PALM BEACH COUNTY PLANNING, ZONING AND BUILDING DEPARTMENT ZONING DIVISION

BOARD OF ADJUSTMENT STAFF REPORT 1/19/2006

T	T	
AGENDA ITEM	CODE SECTION	REQUIRED	PROPOSED	VARIANCE
BA-2005- 01699	5.B.1.A.2.e Fence Walls & Hedges - Residential Districts – Front.	4 ft max fence height in front setback; 6 ft max height in side and rear setbacks	8 ft high, black vinyl, chain link fence on all sides.	4 ft variance in front. 2ft variance in sides and rear.

SITE PLAN

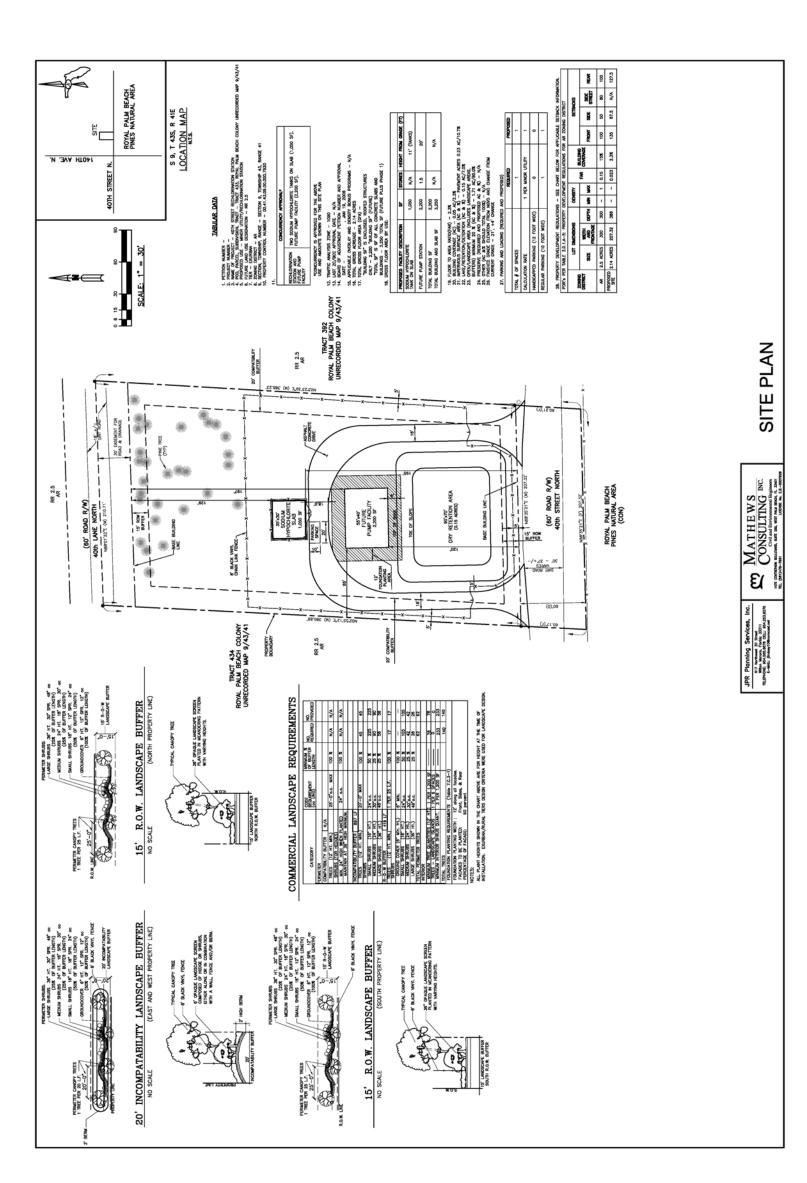
7.F.3.A Landscape - Walls & Fences: Conflict of Easement	75% of trees on exterior of fence.	Hedge only on outside of fence on south, east and west sides.	No trees on outside of fence on south, east and west sides

7.C.3 U/S Tier Side Facade Foundation Planting	Berms only allowed with approved ALP	2 foot berm on east and west property lines without ALP	2 ft berm on east and west without ALP

6.A.1.B-1 Minimum Parking	1 space per minor utility	No designated parking space (unstaffed facility)	1 less parking space
	7.C.3	Fence must be made of natural materials such as stone or wood	Black vinyl chain link	Fence material black chain link rather than natural material
SITUS ADDRESS:	13831 40 St N West Palm Beach 33411			
AGENT NAME & ADDRESS:	Jean Lindsey JPR Planning Services, Inc. 617 NW 30 St Wilton Manors FL 33311			
OWNER NAME &	3200 Belvedere Rd			
ADDRESS:	West Palm Beach FL 33406			
PCN:	00-41-43-09-00-000-7920			
ZONING DISTRICT:	AR			
BCC DISTRICT:				
PROJECT MANAGER:	Timothy Sanford, Planner I			
LEGAL AD:	JPR Planning Services, agent, for Palm Beach County Property and Real Estate Management Division, owner, to allow a proposed fence to exceed the maximum height and be of non-natural materials; to eliminate the required parking space; to have a two foot berm; to allow a hedge outside the fence. LOC: Vacant lot on 40th Rd. North, approx. 0.35 mile W of Avocado Blvd. and approx. 0.45 mile S of Orange Grove Blvd., in the AR Zoning District (PET: 2005-565).

Approval with conditions, based upon the following application of the standards enumerated in Article 2, Section 2.B.3 of the Palm Beach County Unified Land Development Code (ULDC), which a petitioner must meet before the Board of Adjustment may authorize a variance.

Prior to DRO Approval, the applicant shall have the approved variances, pursuant **BA-2005-1699**, labeled on the site plan. (DRO: EVENT: ZONING)
